ROTAX MOJO MAX CHALLENGE

Regulations 2008

Bulletin 11 09.06.2008 (changes underlined)

125 MAX / 125 Junior MAX

Illustration 5

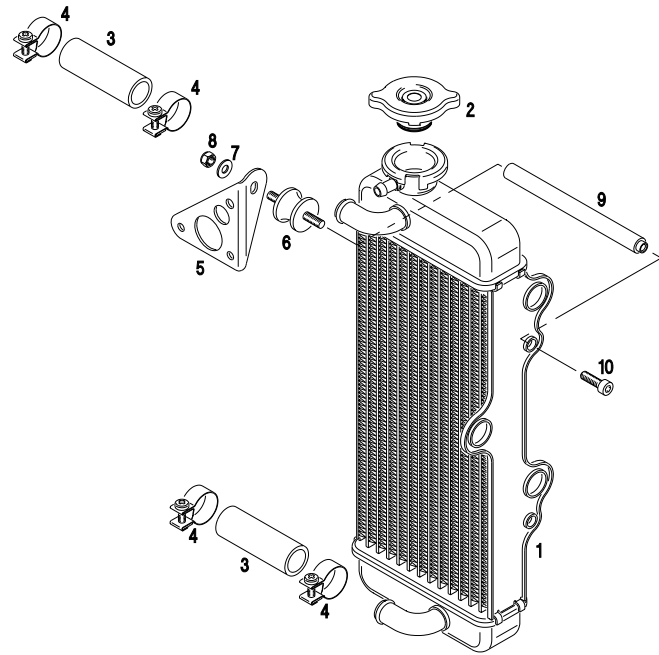
Radiator	18.1	Single aluminium radiator as shown in illustration
	18.2	Cooling area: Height = 290 mm, width = 133 mm
	18.3	Thickness of radiator = 32 mm
	18.4	Place of fixing the radiator is on right side of engine.
	18.5	Radiator must be mounted with all components as shown in the illustration either like version 1 or like version 2. <u>At version 2 there is 2 legal options to mount the radiator to the retaining plate (see drawing for details)</u>
	18.6	No additional cooling device is allowed. Tape applied around the radiator is the only allowed air flow control. Tape may not be removed from the radiator during operation on the track. All other means of air flow control through the radiator are prohibited.
	18.7	The removal of the thermostat from the cylinder head cover is an acceptable configuration.
